Enclosure 3 to E-54257

RAI Responses

Safety Analysis Report (SAR), Chapter 2, "Site Characteristics"**RAI NP-2.2-1:**

**Figure 2-3
Proposed WCS CISF 1-mile Radius**

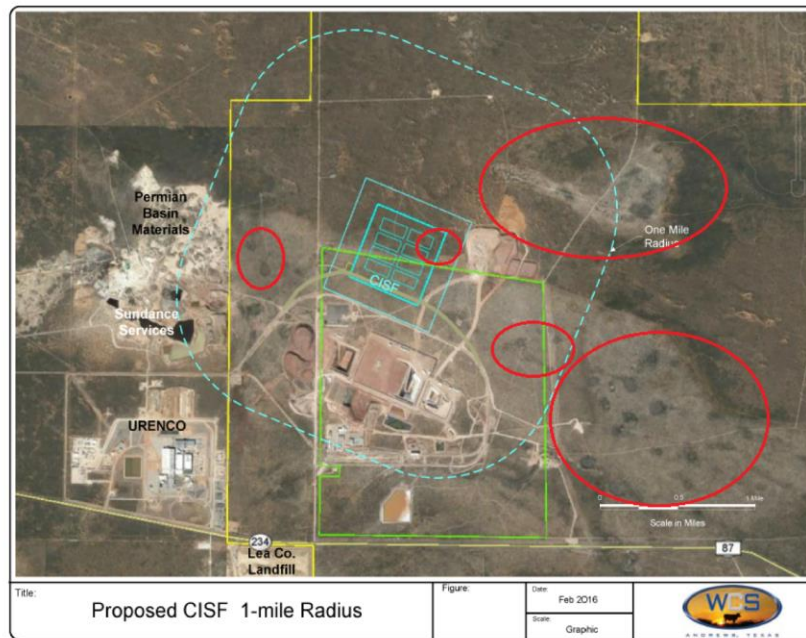
Clarify the origin of the circular features as identified in the red circles on Figure 2-3 below. Specifically, provide the dimensions of the features and determine whether they might represent surface deformation at the site due to subsurface dissolution resulting from past or ongoing natural processes or human activities in the site area, as mentioned in WCS CISF SAR Section 2.6.1. Also, discuss the potential for similar features to develop at the site in the future.

WCS CISF SAR Section 2.6.1 states, “near-surface regional structural controls may be locally modified by differential subsidence related to groundwater dissolution of Permian salt deposits.” However, the SAR does not specify where these locally modified areas of differential subsidence are located relative to the proposed site. The NRC staff noted the history of oil and gas exploration and extraction activities in the site area and the presence of some features in SAR Figure 2-3 that are circular in shape (i.e., similar to sinkholes or swales), some of which are shallow depressions 2 to 7 feet in depth.

Response will be provided in a separate submittal in the near future.

**Figure RAI NP-15-8-1
Clearance Study**

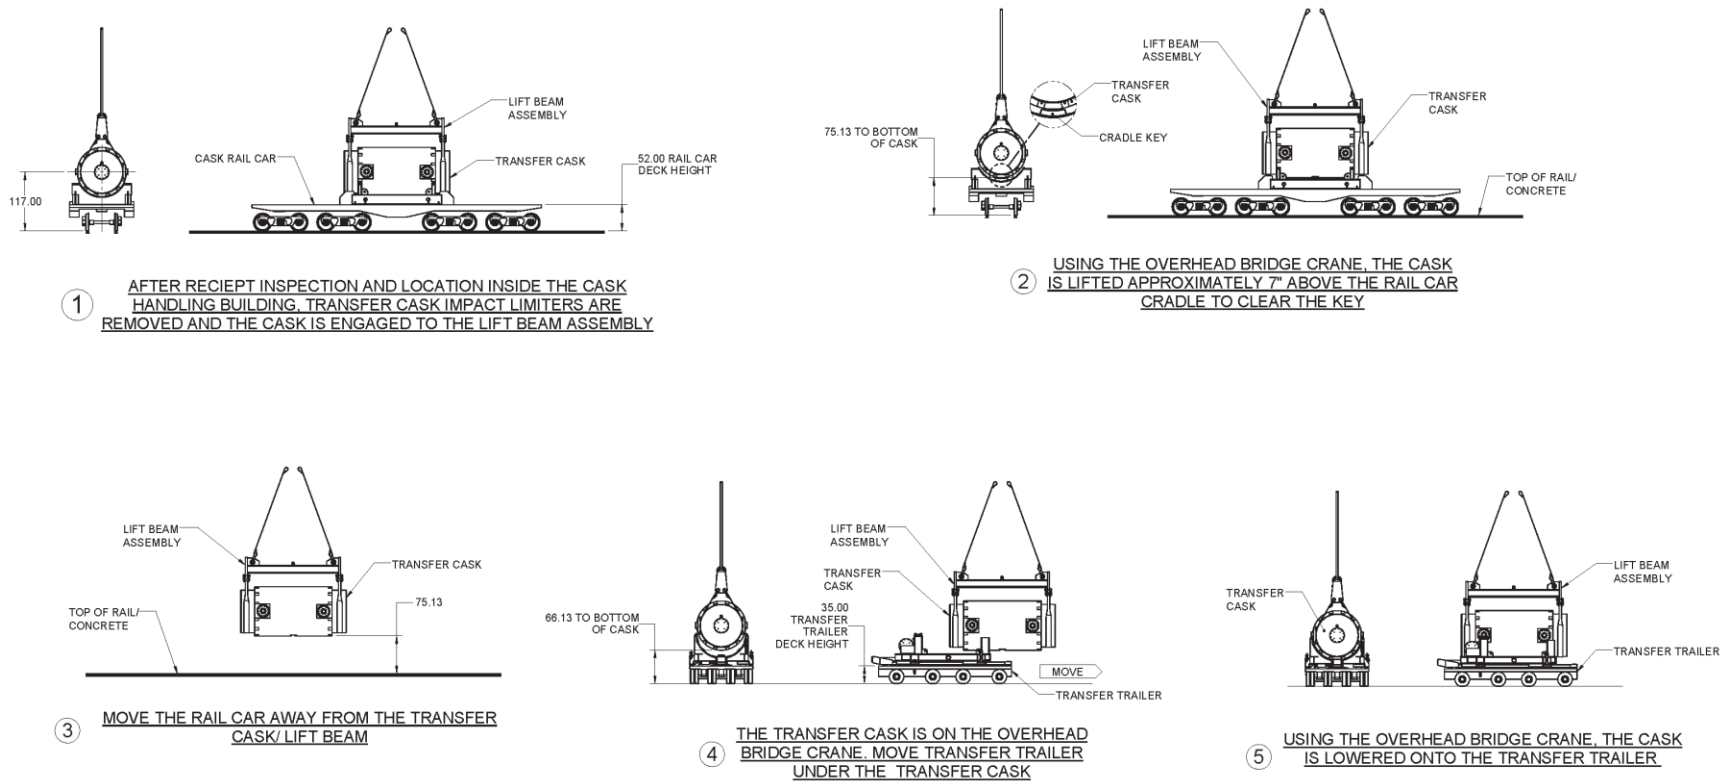
Provide additional information to justify the classification of the 130-ton Crane and the WCS Lift Beam as NITS Components based on the NUHOMS system transfers being limited to heights of less than 80 inches.

The transfer operation (shown in WCS CISF SAR Figure A.5-1) of the loaded MP187 from an incoming railcar to the NUHOMS Transfer Trailer that takes place in the canister handling building (shown in WCS CISF SAR Figure 1-7) appears to involve a lift of the NUHOMS system that is greater than 80 inches because the underside of the MP187 transfer cask (in the horizontal position as shown in Figure A.5-1) will be lifted above the trunnion attachment points on the MP187 Transfer Trailer. As described, the dimensions of the MP187 Transfer Trailer and the MP187 Cask, and the description of the WCS canister handling building and the transfer operation do not support a lift height of no more than 80 inches.

To verify that the NUHOMS[®] MP187 and MP197 transfer casks can be moved from the railcar to the transfer trailer and skid without lifting the casks above 80 inches above the floor of the Cask Handling Building (CHB), ISP performed a clearance study. ISP reviewed the drawings for several Kasgro Rail Corporation railcars that are suitable for use in transporting these casks. Of the suitable railcars that could be used to transport the casks and contents, ISP chose the highest railcar deck as the basis of its study, which is 52 inches above the floor of the CHB. The transfer trailer that will be used at the WCS CISF has an adjustable deck height. During the transfer of the cask from the railcar to the transfer trailer the deck height is set at 35 inches above the CHB floor.

Figure RAI NP-15-8-1 is a summary of the clearance study performed using solidworks models of the skids, cask and trailer deck heights showing the distance between the bottom of the horizontal cask and the CHB floor at the lift heights required to clear the skids and allow free movement of the cask from the transportation skid attached to the railcar to the transfer skid attached to the transfer trailer. As shown in Figure RAI NP-15-8-1, the cask must be lifted 7 inches above its resting position on the transportation skid to allow it to clear the key way and the balance of the skid. This results in the cask being lifted to less than 76 inches from the floor of the CHB. To load the cask onto the transfer trailer, it can be lowered to just over 66 inches and then slid onto the transfer skid and then set down on the trunnion towers as shown in Figure RAI NP-15-8-1.
